Access Compliance Report

Public Rights-of-Way

Intersection ID: 32201	Main Street: HUXLEY_RD	Cross Street: REAVENCREST_PARK_DR	Location: SW
ADA ID: 675CBB8E81CC	Ramp Type: PerpDiag	Initial Pass/Fail: Fail	Overall Compliance: No
Severity Score: 30			
Codes/Mitigation Info/Possible Solution		Field Measurements/Component Compliance

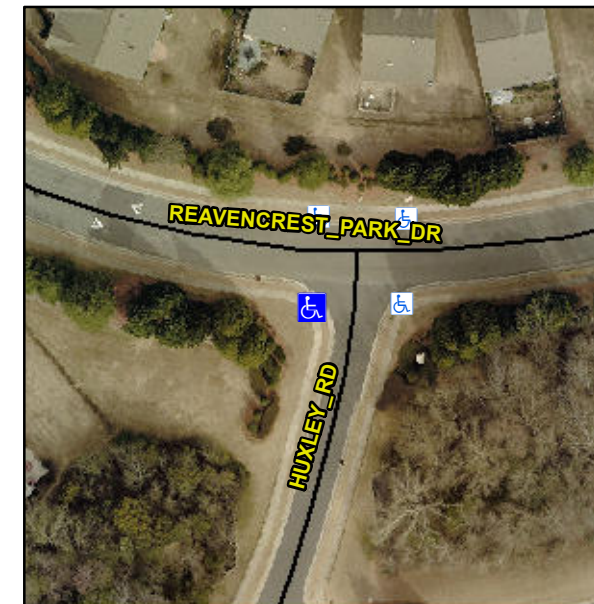
R304.5.1, R304.5.3

Compliance	Description	Data	Compliance	Description	Data
N/A	Ramp Length (in)	96.0	Yes	Ramp Slope (%)	6.3
No	Ramp Width (in)	34.0	No	Ramp XSlope (%)	6.5
N/A	Flare Type LT	N/A	N/A	Flare Type RT	N/A
N/A	Flare Slope LT (%)	N/A	N/A	Flare Slope RT (%)	N/A
N/A	Flare Traversable LT?	N/A	N/A	Flare Traversable RT?	N/A
N/A	Landing Length (in)	N/A	N/A	DWS Provided?	N/A
N/A	Landing Width (in)	N/A	N/A	DWS Contrast?	N/A
N/A	Landing Slope (%)	N/A	N/A	DWS Length (in)	N/A
N/A	Landing X Slope (%)	N/A	N/A	DWS Full Width?	N/A
N/A	Landing Curb? (Y/N)	N/A	N/A	DWS Offset (in)	N/A
N/A	Shared Landing?	N/A			
N/A	Gutter Ponding?	N/A	N/A	Gutter Slope (%)	N/A
N/A	Gutter Lip Ht (in)	N/A	N/A	Gutter X Slope (%)	N/A
N/A	Painted X Walk1?	No	N/A	Painted X Walk2?	No
	X Walk 1 Direction	To E		X Walk 2 Direction	To N
N/A	X Walk 1 Width (in)	N/A	N/A	X Walk 2 Width (in)	N/A
	X Walk 1 Slope (%)	2.1		X Walk 2 Slope (%)	3.8
	X Walk 1 X Slope (%)	5.6		X Walk 2 X Slope (%)	2.4

Remove & Replace Curb Ramp With Two New Directional Ramps or Equivalent.
